CHANGE ORDER NO.: 6

| Project: | WWTP Improvement Project | | |

Town of Bristol
WWTP Improvements Project
Change Order #6

**RE: Job Number S22145
 WWTP Improvement Project
 Proposed Change Order No. 6**

- Revised structural drawing S2-5

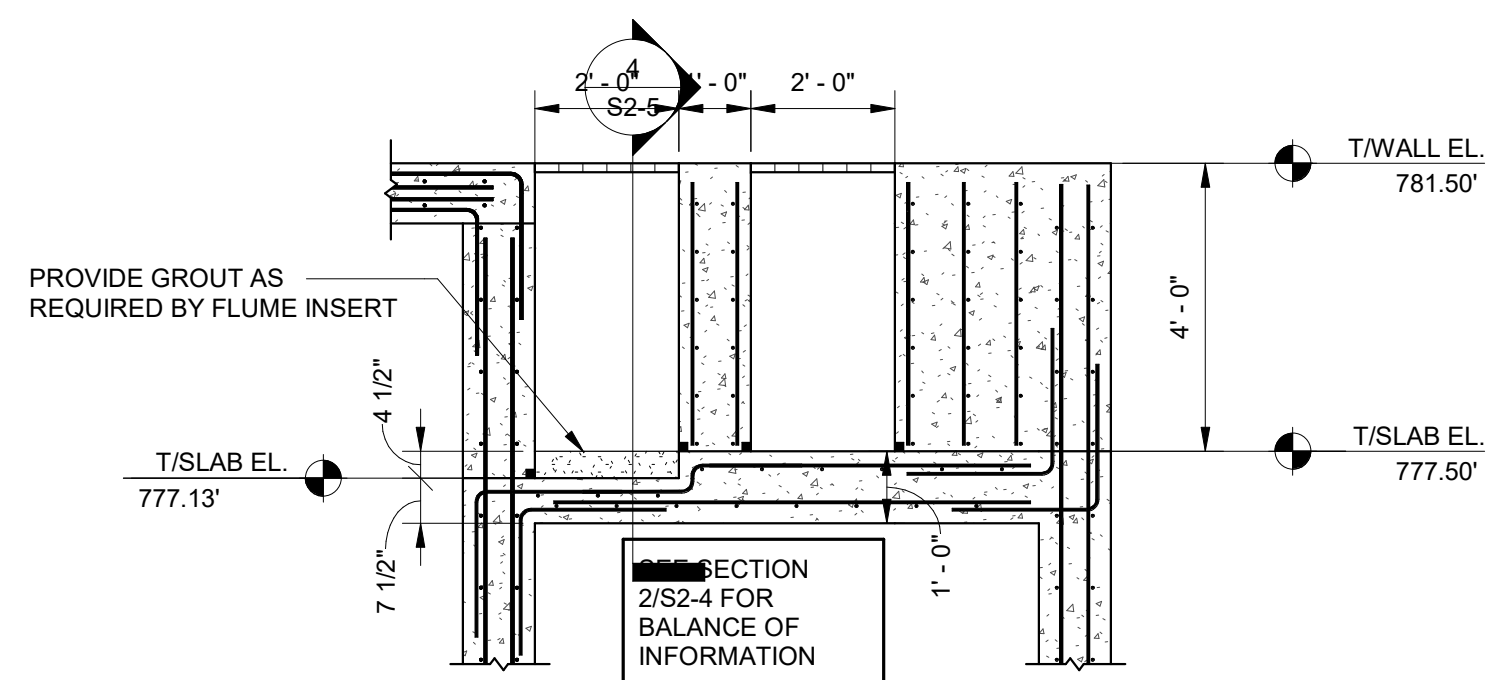
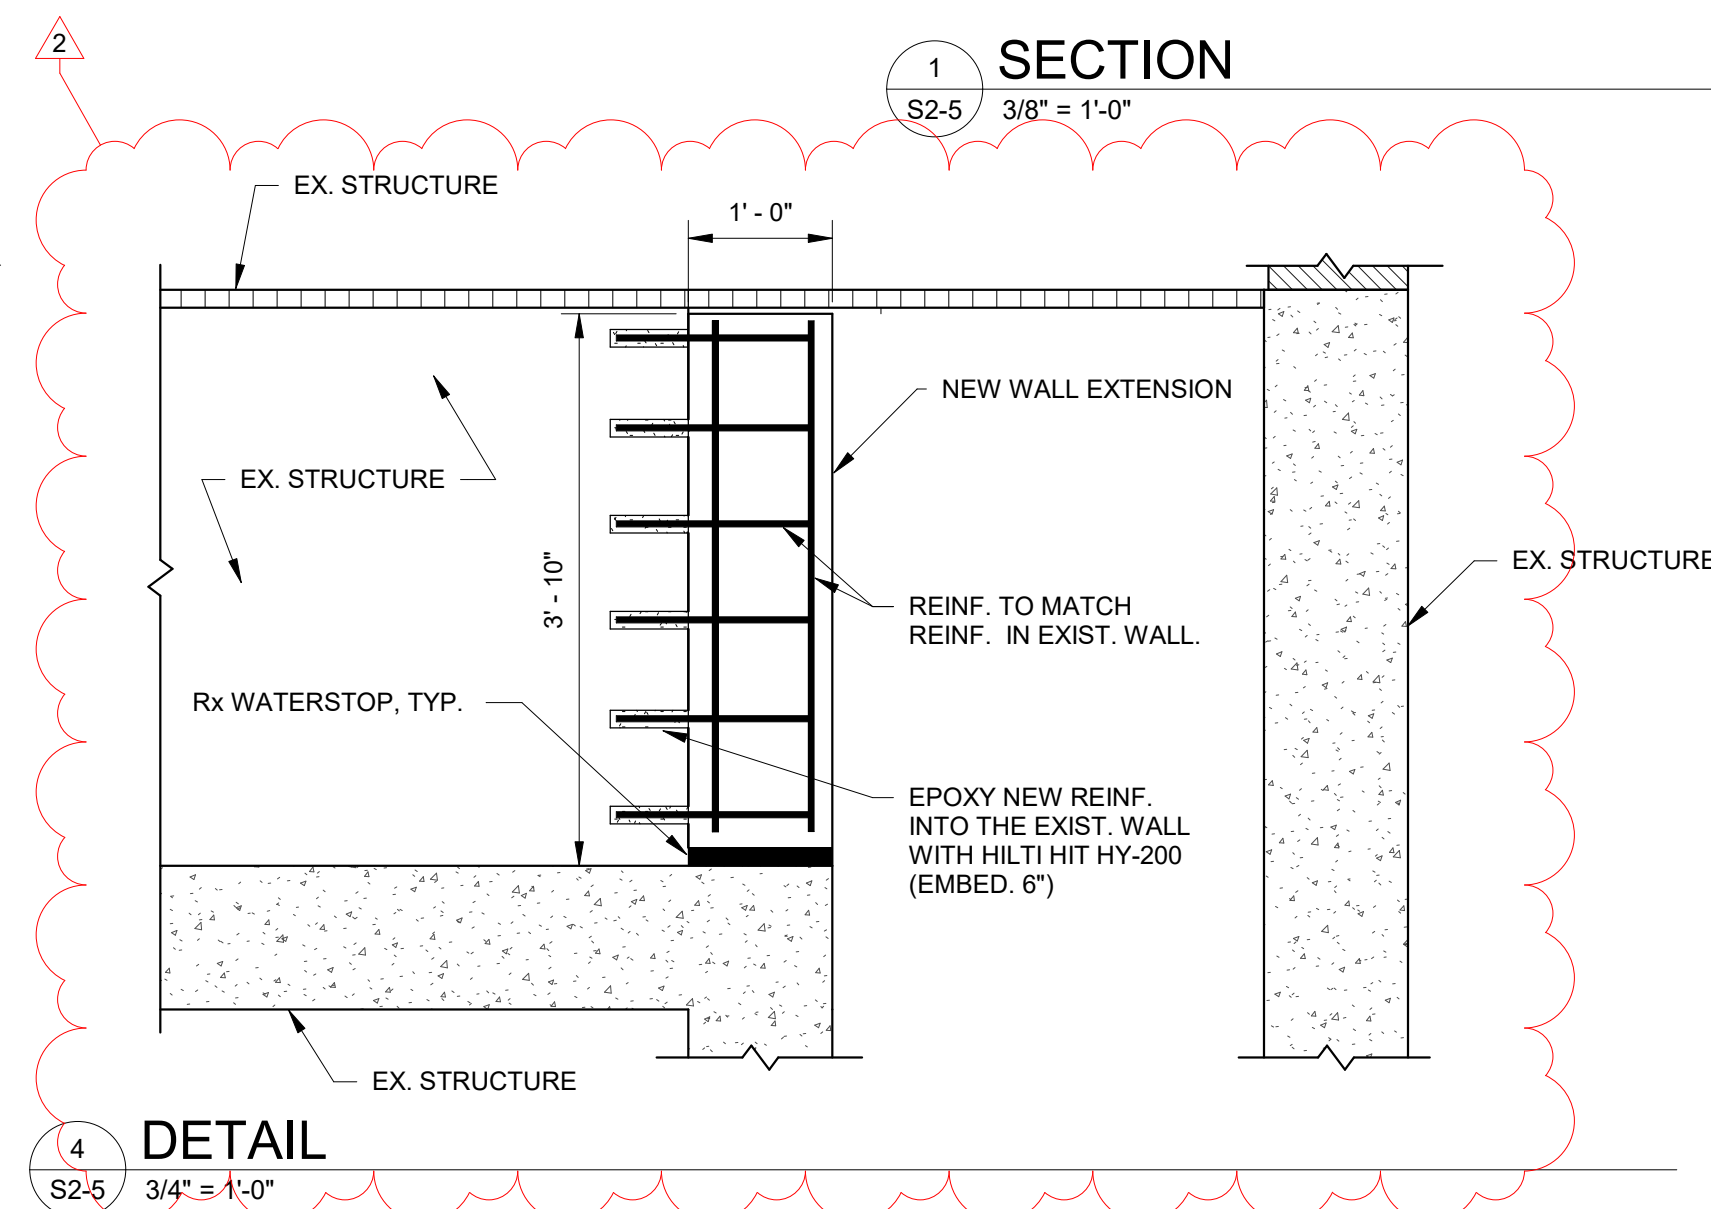
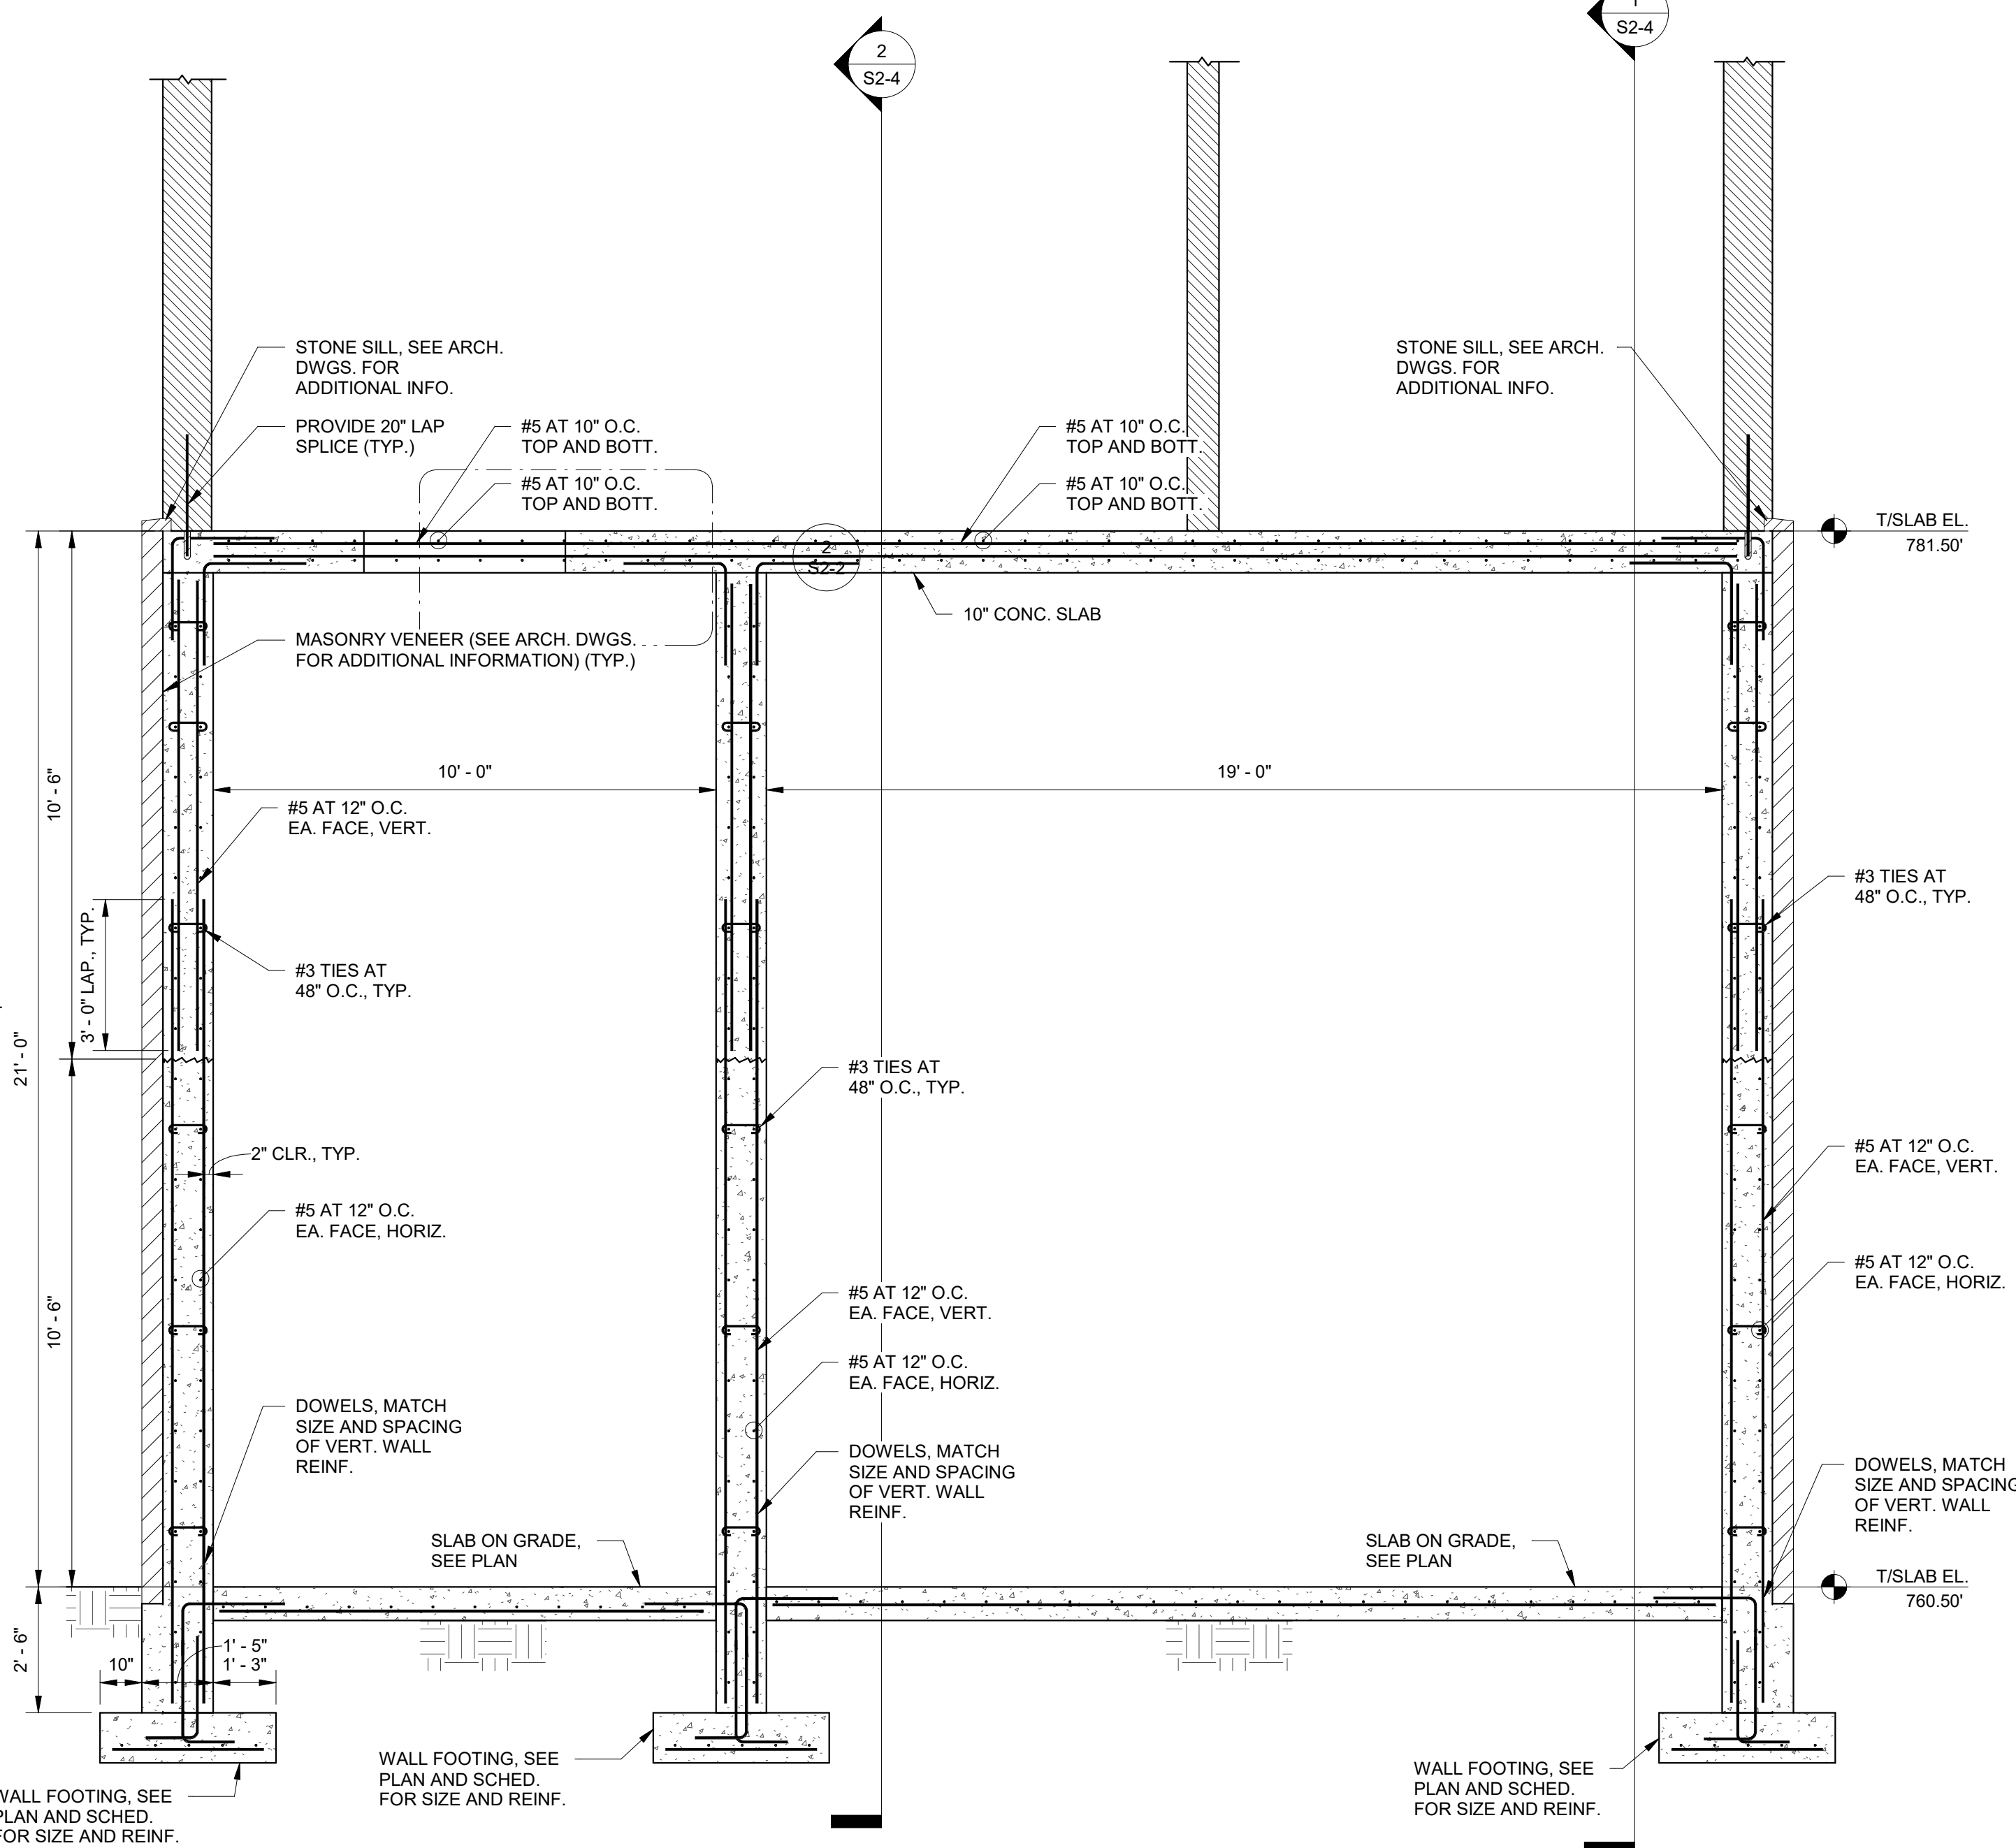
A discrepancy between the process and structural drawings resulted in the channel wall separating the headworks screen channel and bypass channel being constructed 1 foot too short. This issue was identified when the Contractor noted that the flume would extend beyond the end of the wall. The separation wall is required to properly divide the channels prior to the sump and anchor the flume. To correct this, the wall was extended by 1 foot. The Town authorized this work to take place tracking time and material (T&M) expended. The work has been completed and Contractor submitted T&M records. This change results in an added cost of \$2,903.88 with no impact to contract time.

1. The channel wall separating the headworks screen channel and bypass channel was constructed 1 foot too short due to a discrepancy between the process and structural drawings on the length of the channel wall prior to the sump. The issue was noticed when the Contractor asked about installing the flume with one foot of the flume extending beyond the end of the channel wall.
2. The channel separation wall is necessary to separate the channels prior to the sump.

1. The channel wall shall be extended by 1 foot following the attached revised plan sheet S2-5.
2. The flume shall be installed against the extended wall.
